SOLICITATION AMENDMENT
MODIFICATION DE L'INVITATION

Title - Sujet Exterior Lighting Additions	
Solicitation No. - N° de l'invitation EZ899-161037/B	Amendment No. - N° modif. 003
Client Reference No. - N° de référence du client	Date 2015-10-23
GETS Reference No. - N° de référence de SEAG PW-\$PWY-032-7627	
File No. - N° de dossier PWY-5-38174 (032)	CCC No./N° CCC - FMS No./N° VME
Solicitation Closes - L'invitation prend fin at - à 02:00 PM on - le 2015-10-30	
F.O.B. - F.A.B. Plant-Usine: <input type="checkbox"/> Destination: <input checked="" type="checkbox"/> Other-Autre: <input type="checkbox"/>	
Address Enquiries to: - Adresser toutes questions à: Large, Kathy(pwy)	Buyer Id - Id de l'acheteur pwy032
Telephone No. - N° de téléphone (604) 666-2891 ()	FAX No. - N° de FAX (604) 775-6633
Destination - of Goods, Services, and Construction: Destination - des biens, services et construction: Parks Canada - Fort Rodd Hill National Historic Site - Victoria, BC

The following changes in the tender documents are effective immediately. This addendum will form part of the contract documents.

ESKI-E102

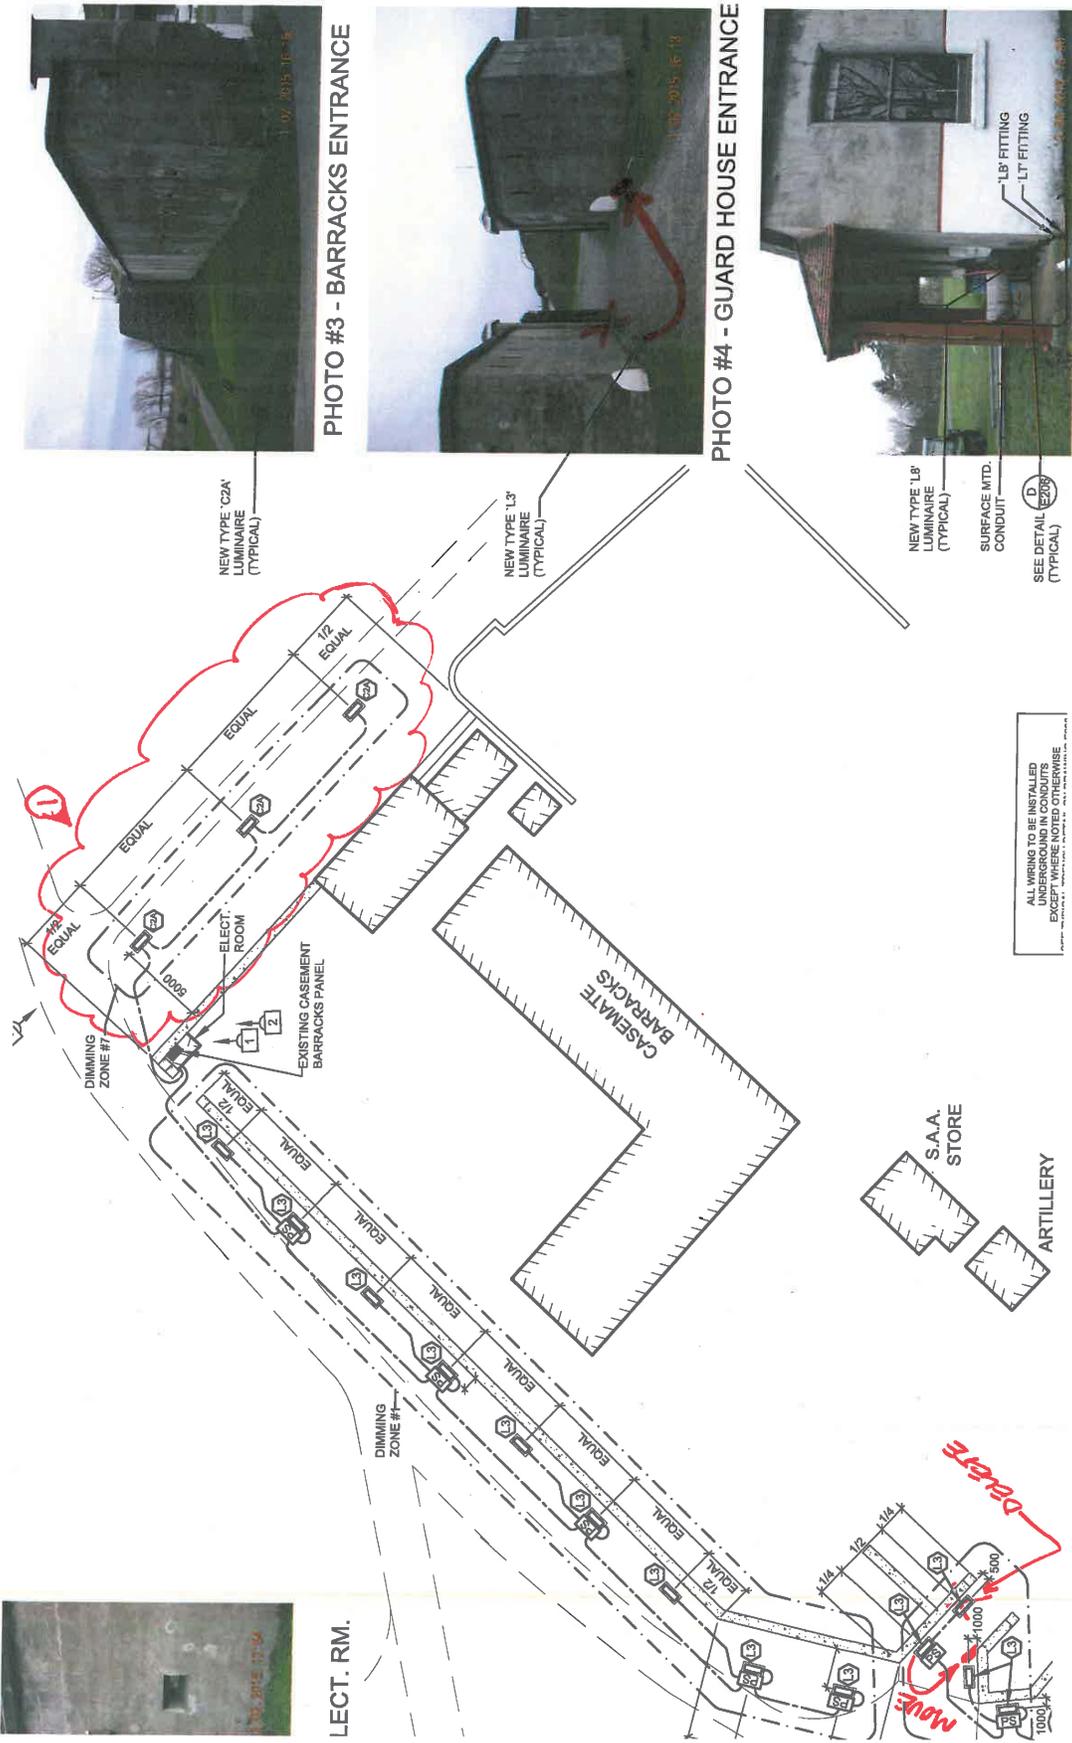
.3 Drawings E102 – Refer also to the attached ESK1-E102

- (3) **Add** : keynote #1 to read:
"Very archaeologically sensitive area. Refer also to Appendix 'B' in the specifications. No machine digging; only hand digging is allowed in this area. Review the results of archaeological testing and pre-construction coring with Departmental Representative prior to any trenching. Distance of luminaires from the wall may need to be reduced to 2m depending on the results of testing."

- (4) **Move** : one type 'L3' luminaire as noted in ESK1-E102 at entrance to Lower Battery area.
- (5) **Delete**: one type 'L3' luminaire as noted in ESK1-E102 at entrance to Lower Battery Area.

- (6) **Revise**: note for photo #6 to read:
"Remove the wooden cabinet enclosing the exiting panelboard and receptacle. Replace the existing panelboard with a new 8-cct. Stab-lok load centre c/w sufficient circuit breakers to re-feed existing circuits and new lighting circuit. Provide a new lockable stainless steel cabinet to enclose the new load centre,
-

existing receptacle, new lighting control panel #3 and programmable switches for lighting zone #6.”

- (7) **Revise:** routing of conduits from Casement Barracks electrical room to type ‘C2A’ and ‘L3’ luminaires. Refer also to photos #1 and #2. Instead of drilling into the historic fabric of red brick wall as shown in photo #1, route the conduits from the wall of the electrical room down into u/g and out of the electrical room using existing gap area in the concrete floor.
- (8) **Add :** to the note pointing to surface mount conduit in photo #5 to read:
“Avoid drilling into historic fabric of wooden post. Fabricate a non-invasive clamp to fit to the post and use to support the conduit. Paint to match the post.”

ESK1-E103

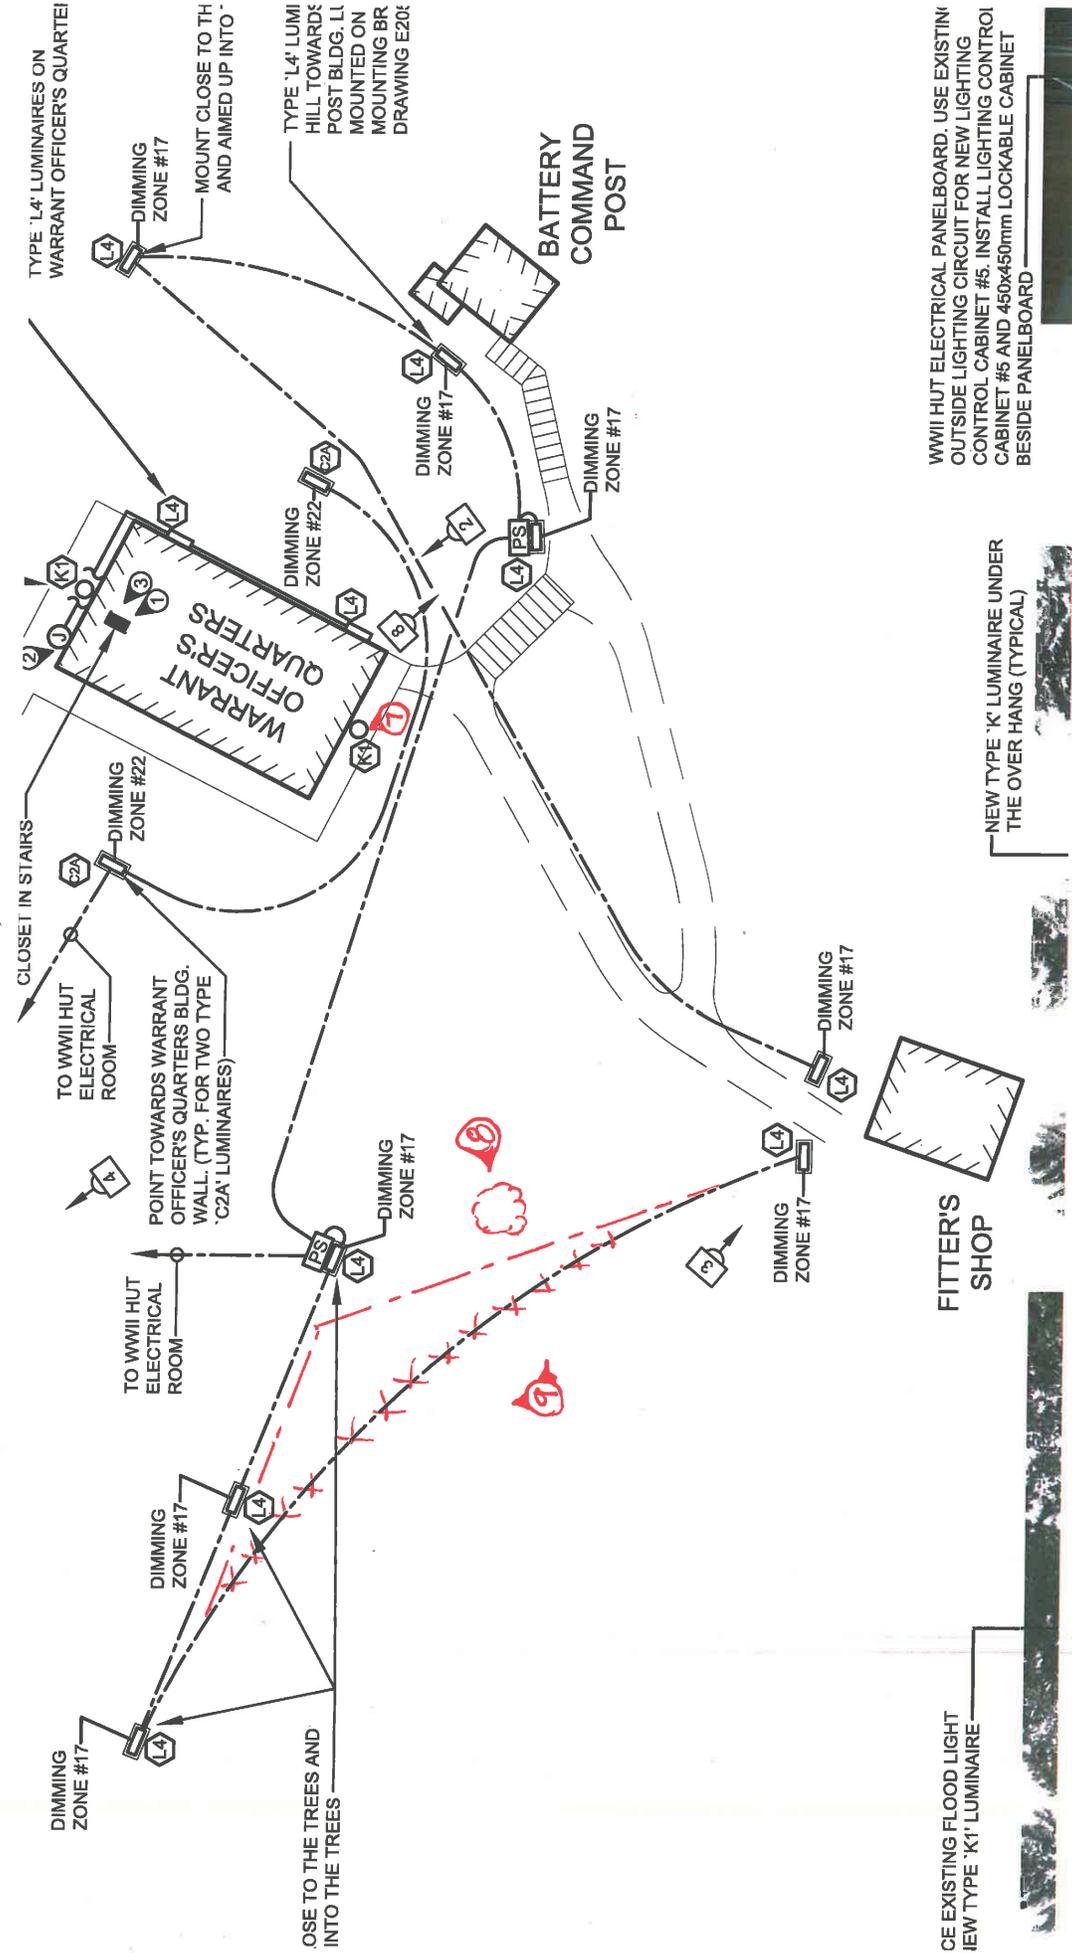
.4 Drawings E103 – Refer also to the attached ESK1-E103

- (9) **Add :** keynote #7 to read:
“Replace existing flood light with new type ‘K1’ luminaire. Do not walk on the adjacent lower roof due to poor condition of the roof. See also photo #2. A boom truck will be required.”
- (10) **Revise :** routing for u/g conduit connecting two type ‘L4’ luminaires in dimming zone #17 as shown in ESK1-E103.
- (11) **Add :** keynote #8 to read:
“Tree with rocks around it. U/g conduits to be installed as far as possible from tree roots.”
- (12) **Add :** keynote #9 to read:
“Heavily-treed area with mature Garry Oak trees. All u/g conduits to be installed as far as possible from tree roots.”

ESK1-E105

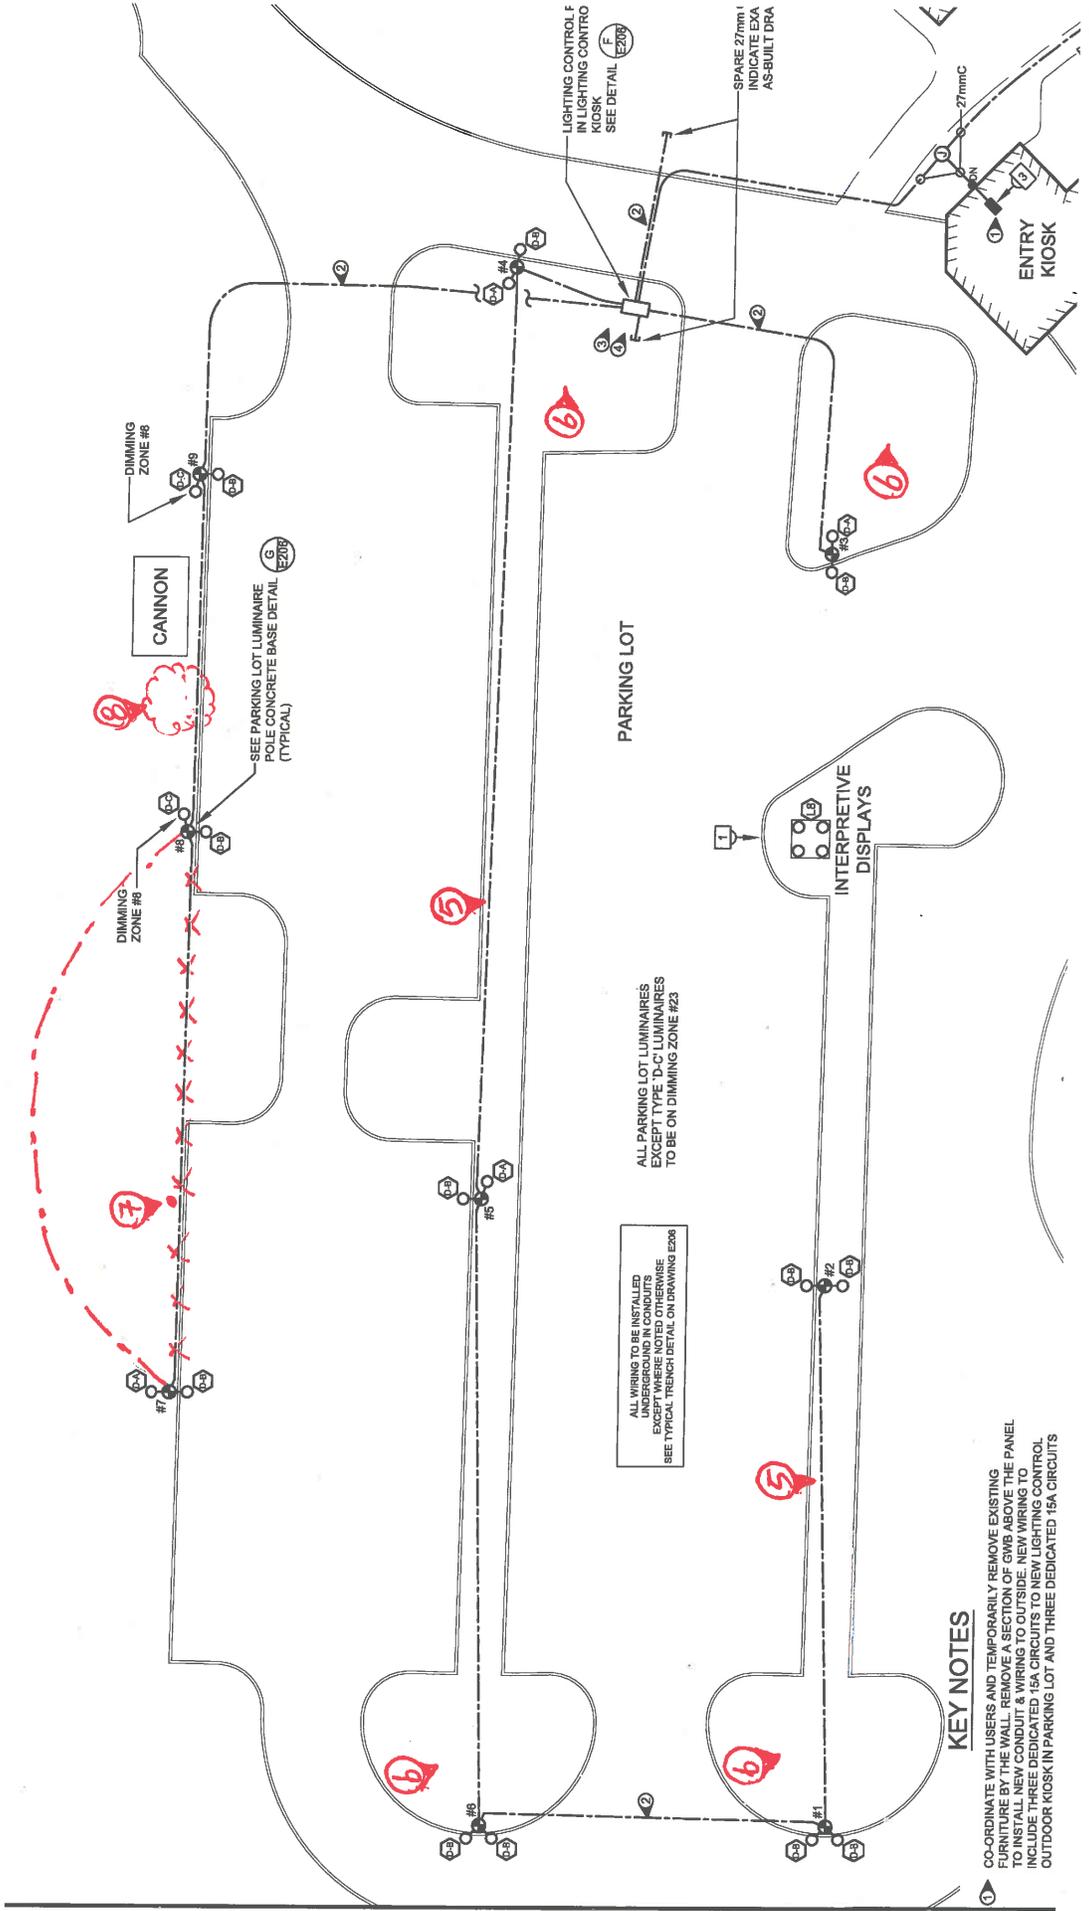
.6 Drawings E105 – Refer also to the attached ESK1-E105

- (14) **Add :** keynote #5 to read:
“There are existing plants and an irrigation line in the centre of the island in the parking lot. Install new u/g conduits at one side of the island as close as possible to the curb to avoid plant roots and irrigation line.”
- (15) **Add :** keynote #6 to read:
“Treed area and bushes. Coordinate with Departmental Representative re routing of u/g conduits in this area. Make allowance for conduit routings other than the
-

straight line shown on the dwgs to avoid any damage to existing plants and tree roots.”

- (16) **Add** : keynote #7 to read:
“Existing BCH pole and cobra head luminaire. Contact BC Hydro for removal of existing cobra head luminaire. Make necessary allowances and pay to BC Hydro.”
- (17) **Revise** : routing of u/g conduit from pole #8 to pole #7 to avoid tree roots in the area.
- (18) **Add** : keynote #8 to read:
“There are existing water pipes and valves in this area. Protect existing services when installing u/g conduit.”

ESKI-EID6

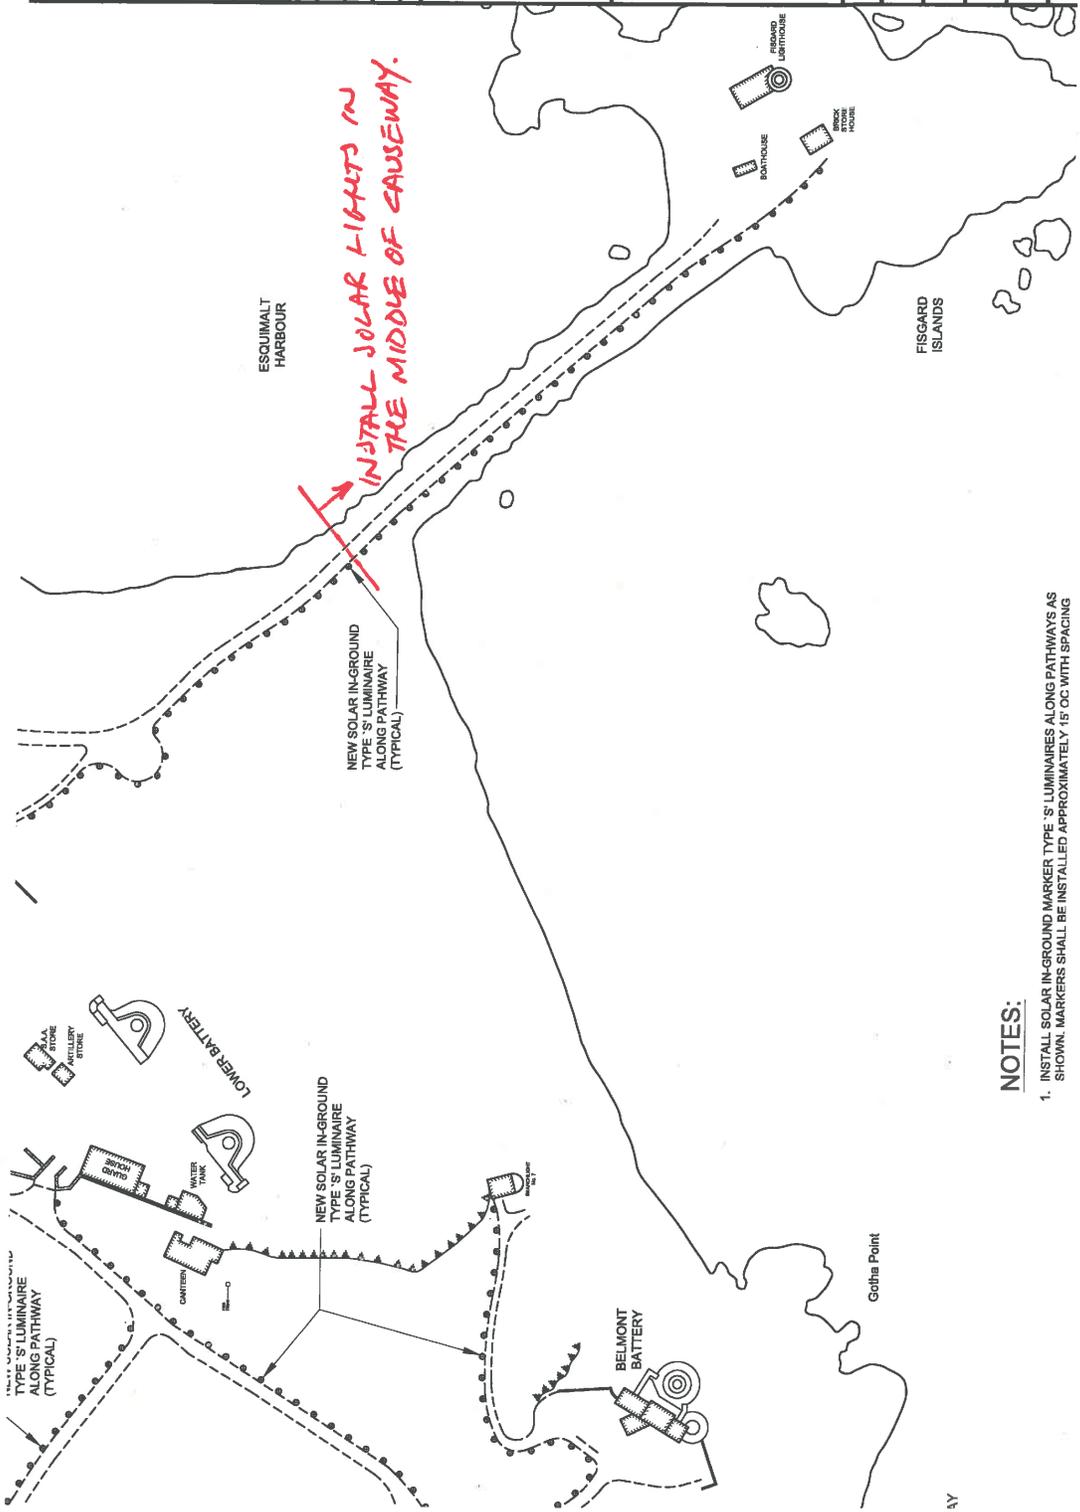
.7 Drawings E106 – Refer also to the attached ESK1-E106

- (19) **Change** : location of in-ground solar lights from side of Causeway to the middle as noted on ESK1-E106 to avoid washout damage.

ESK1-E301

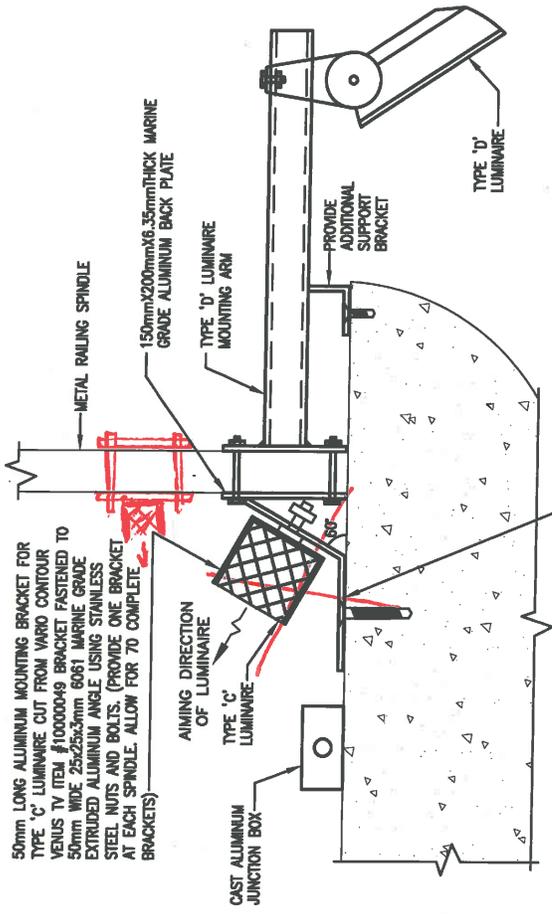
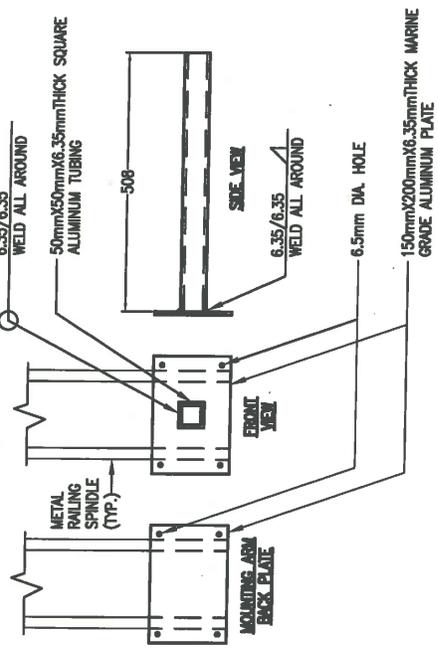
.10 Drawings E301 – Refer also to the attached ESK1-E301

- (22) **Revise** : Revise type of bracket and mounting detail for type ‘C’ luminaire in detail 1. Instead of an angle bracket fixed to the concrete floor, use a flat bracket and fix onto the metal railing spindles the same way as bracket for type ‘D’ luminaires. All brackets to be powder coat painted red to match railings. In addition, color of mounting arm for type ‘D’ luminaires will be confirmed by Departmental Representative.
